Product Change Notification

Date Issued :	April 06, 2023	PCN Number :	513150
Reason for Change :	Equipment Transfer, Production Transfer or Rearrangement		
Description of Change :	This notification is to inform about Production of the impacted part(s) in this PCN has been transferred to different location. No changes will be made to product as part of this change.		
Assessment of Change :	First Article Inspection		
Planned Implementation Date :	October 10, 2023		
Sample Availability Date:	June 15, 2023		
Internal Molex Qualification Date :	June 18, 2023		
Last date to request Samples by Customer :	June 30, 2023		
Traceability Code Markings / Date :	Product made after planned implementation date can contain the change

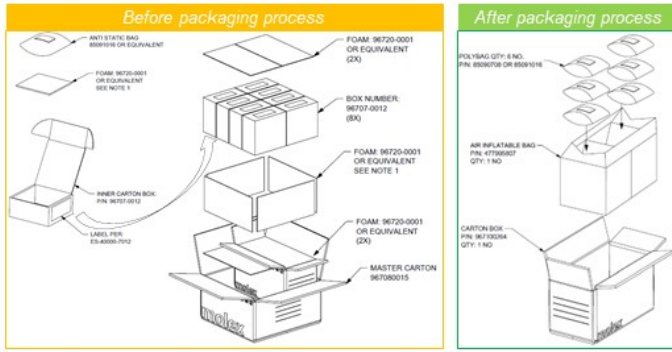
DU & MLQ Change:

- 1) All 6410series parts running in 8204 plant are with Air Inflatable bag packaging.
- 2) Packaging method will be changed for these 9 parts as well.
- 3) There will be change in DU & MLQ qty.
- 4) New packaging change was validated with drop test at 80cm drop height for similar parts.
